Staff Report

Re: Detached Accessory Dwelling Unit – Conditional Use (PLNPCM2019-01051)

PROPERTY ADDRESS: 1083 S Blair Street
PARCEL ID: 16-07-405-009-0000
MASTER PLAN: Central Community
ZONING DISTRICT: R-1/5000 (Single Family Residential)

2 SITE SECTION
SCALE: 1/8" = 1'-0"

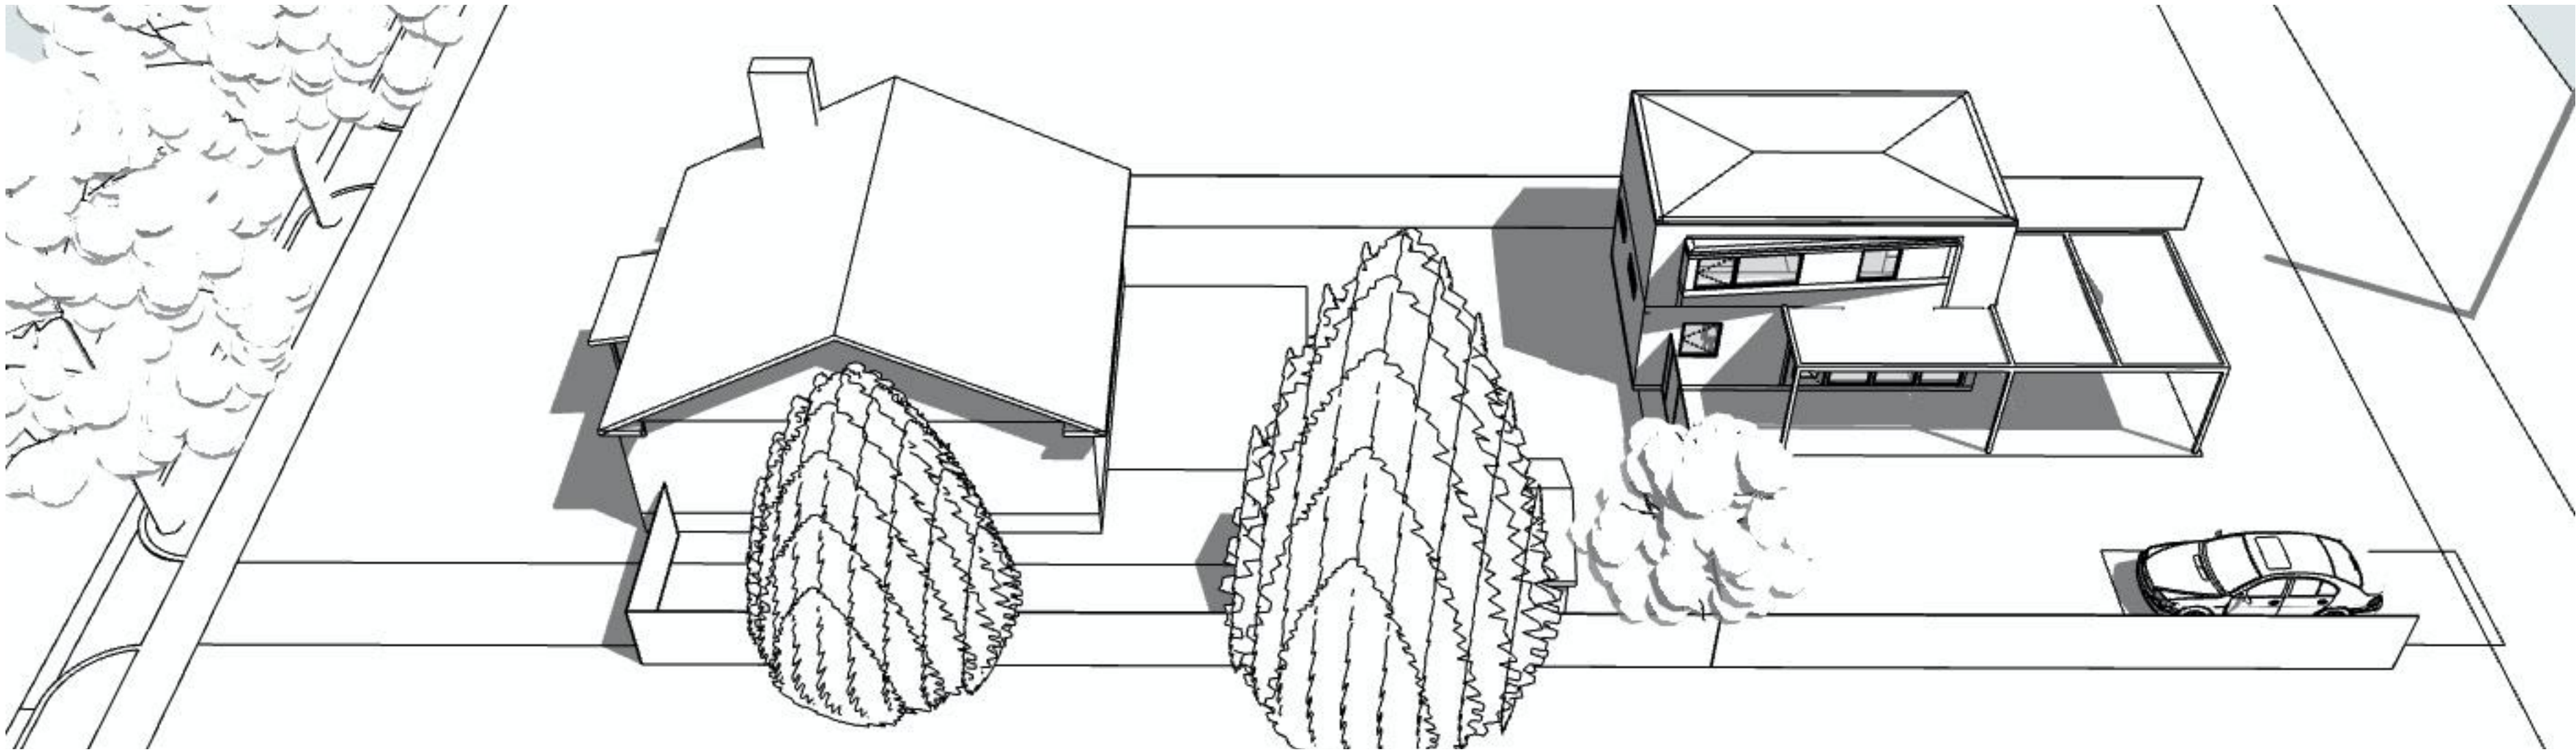
1. Required to attend DRT
2. Need an elevation of the entire property – to make sure the ADU is not taller than 17' or the main structure (whichever is taller)
3. Window on the north elevation – “Windows shall be no larger than necessary to comply with the minimum Building Code requirements for egress where required”. (21A.40.200.E.3.g.1)
4. Total lot coverage by solid roofed structures must be on the site plan

The ADU height is 17' from the grade and below the existing home's height, which is a shade over 20'.

2 SITE-FIRE PLAN
SCALE: 1/8" = 1'-0"

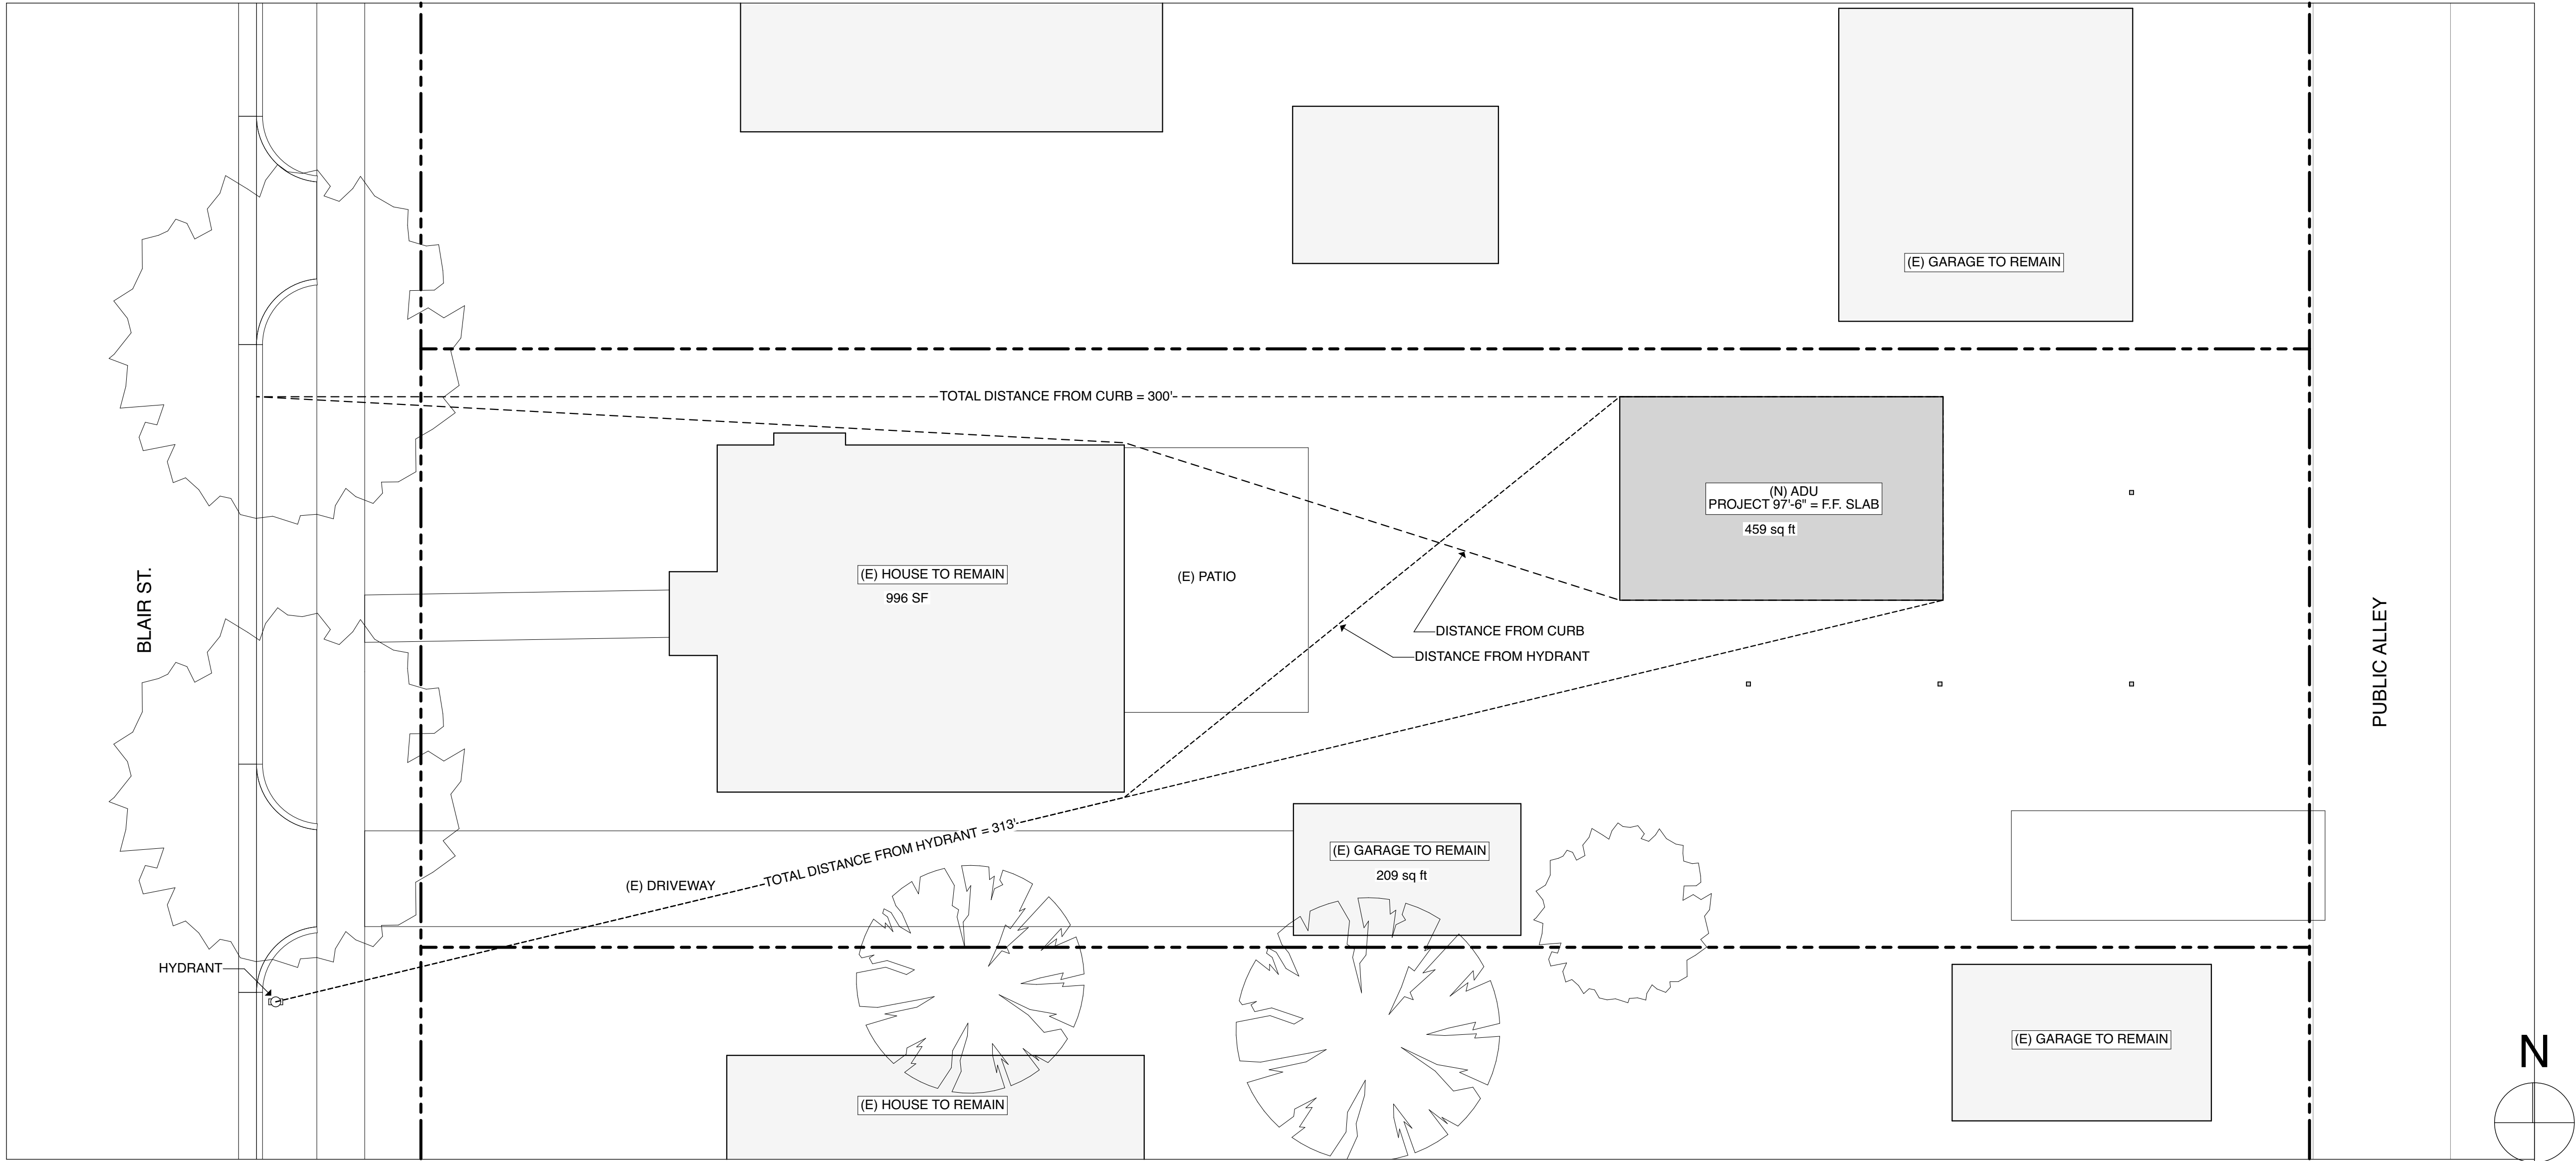
Fire apparatus access road shall extend to within 150-feet of all portions of the building and all portions of the exterior walls of the first story of the building as measured by an approved route around the exterior of the building. Fire apparatus access roads shall have a minimum clear width of 20-feet for buildings 30-feet and under; and an unobstructed clear height of 13-feet 6-inches.

For Group R-3 and Group U occupancies, fire hydrants shall be within 600-feet of all exterior portions of the buildings as measured by an approved route around the building. Provide location of existing or proposed fire hydrants.

During our planning phase, we have met with both Fire Plan Checkers as well as Planners in order to meet the requirements of the ordinance. With regard to fire, we have kept the farthest exterior wall no more than 150' away from the fire access lane, which is Blair Street and we have a fire hydrant well within 600' of the ADU.

1 NORTH ELEVATION
SCALE: 1/4" = 1'-0"

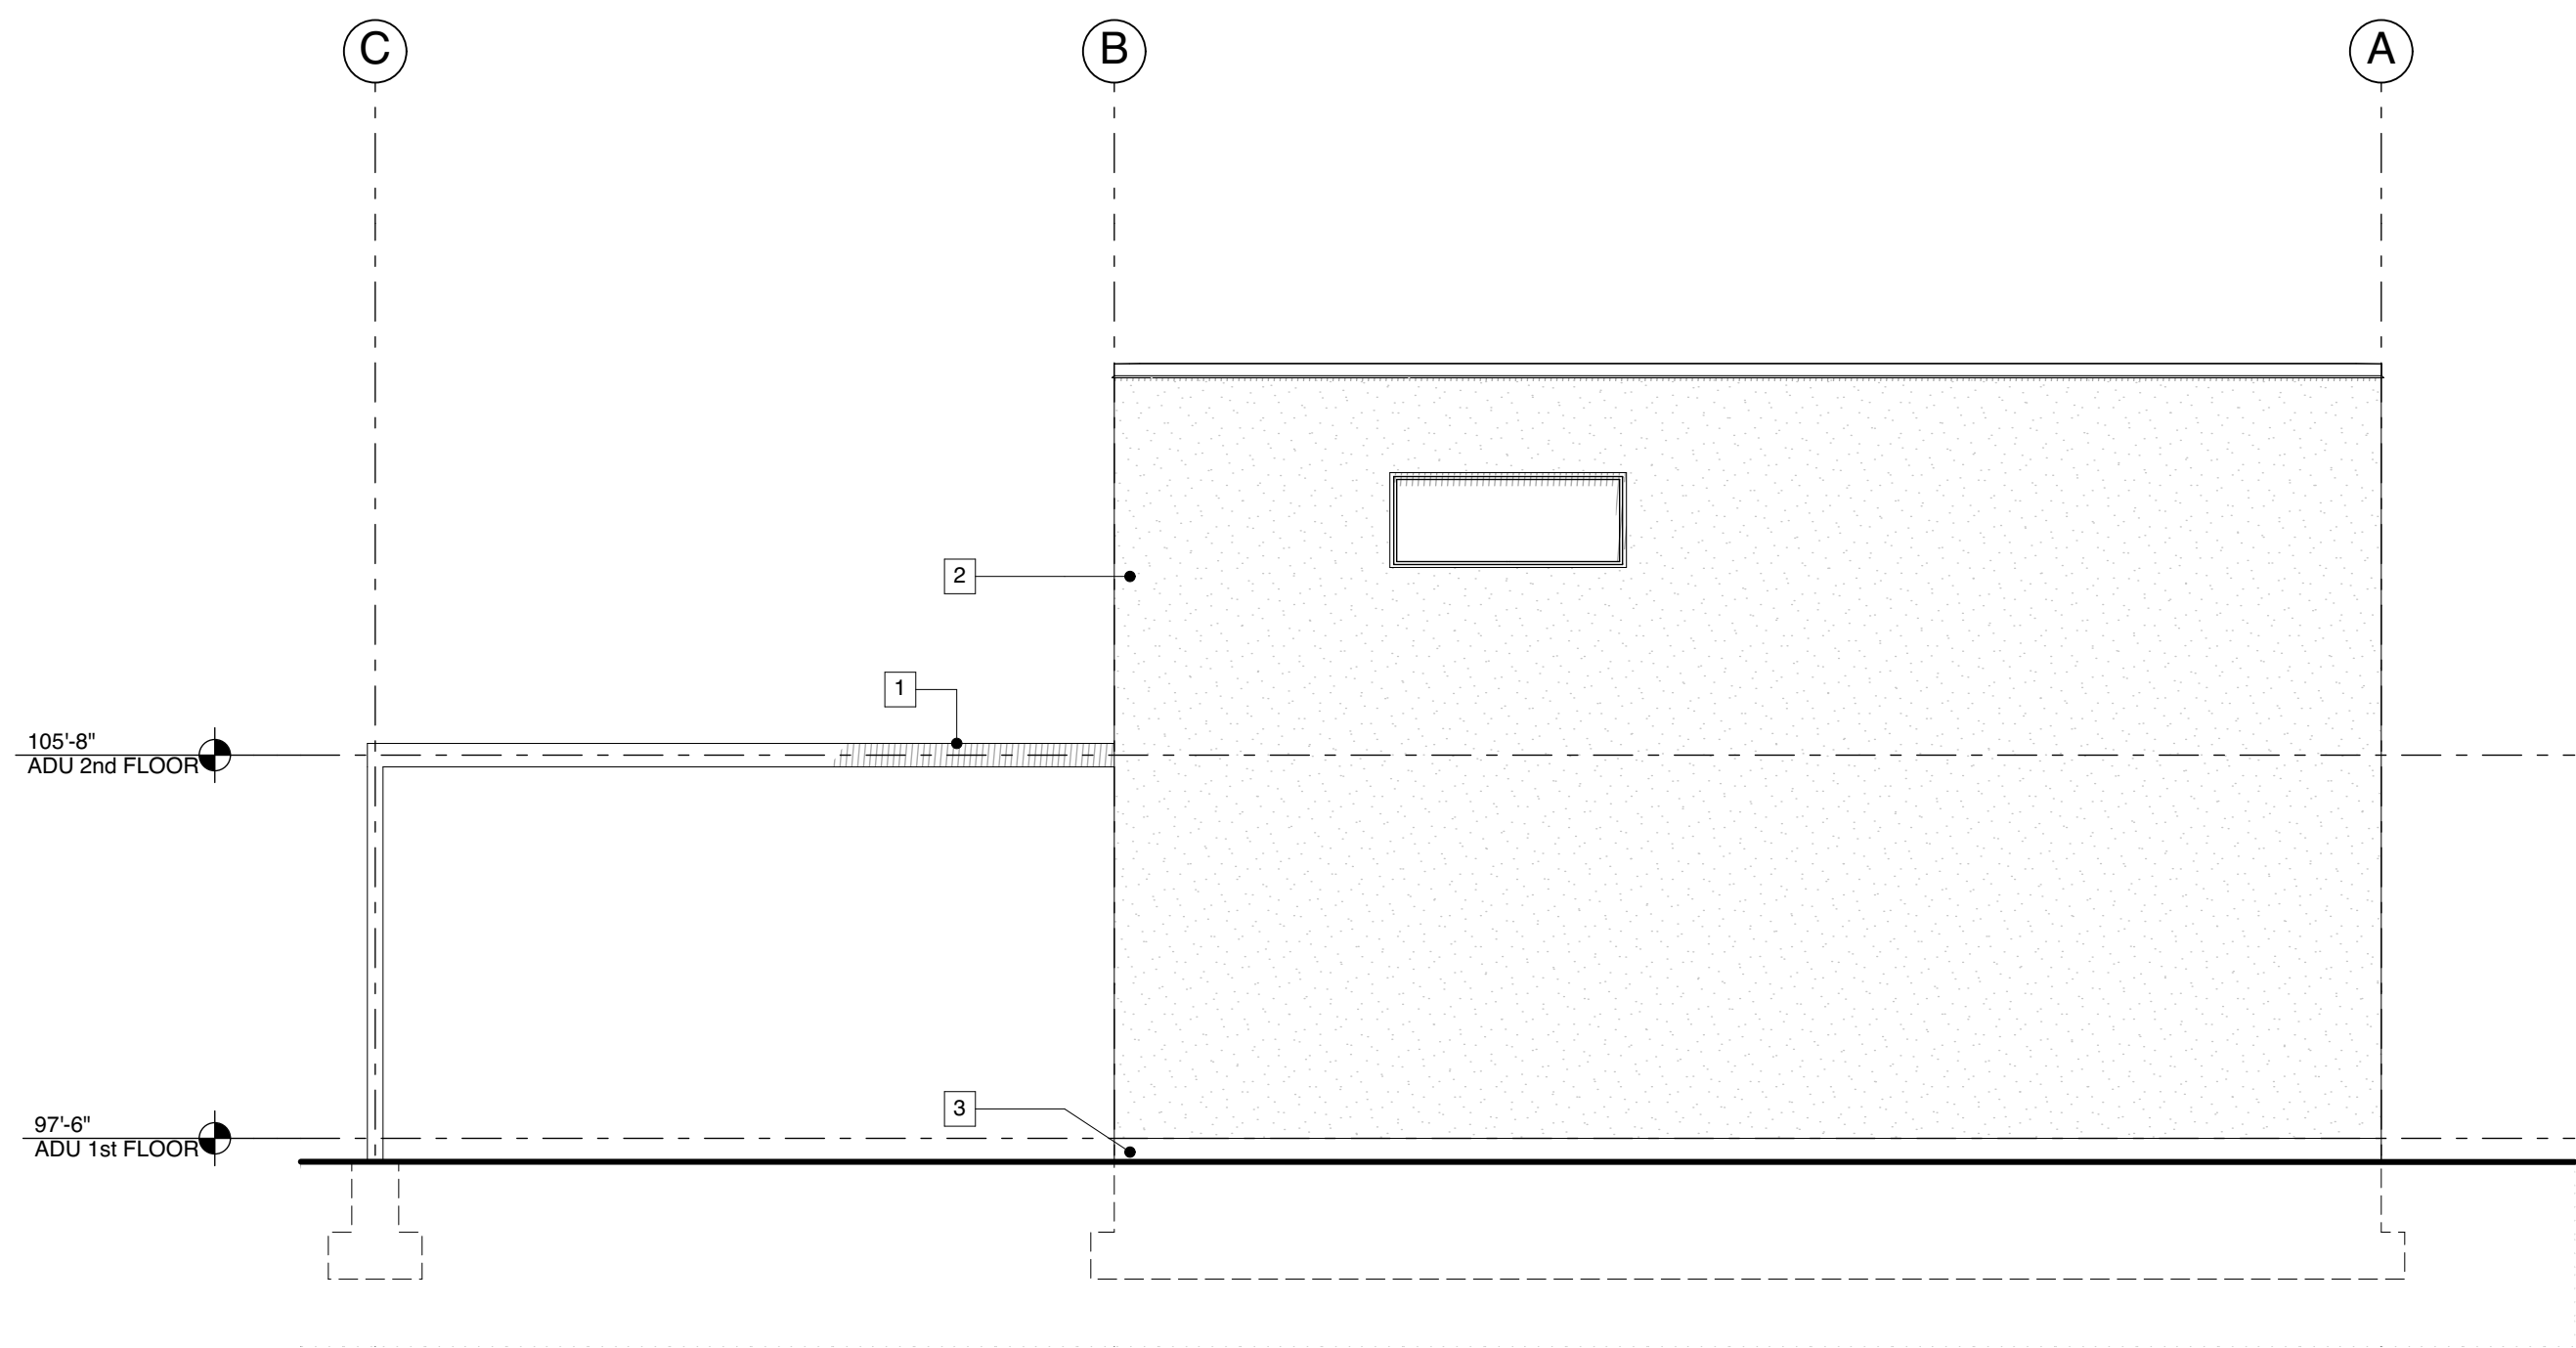
We have received concerns about the window openings on the ADU. Zoning commented that the window on North elevation is too large. That window has been sized down to 5' wide x 2' tall. This is a clerestory window to let in natural light into the great room area. It is the only window on that elevation and it has a sill height of 12'-8" above the grade.
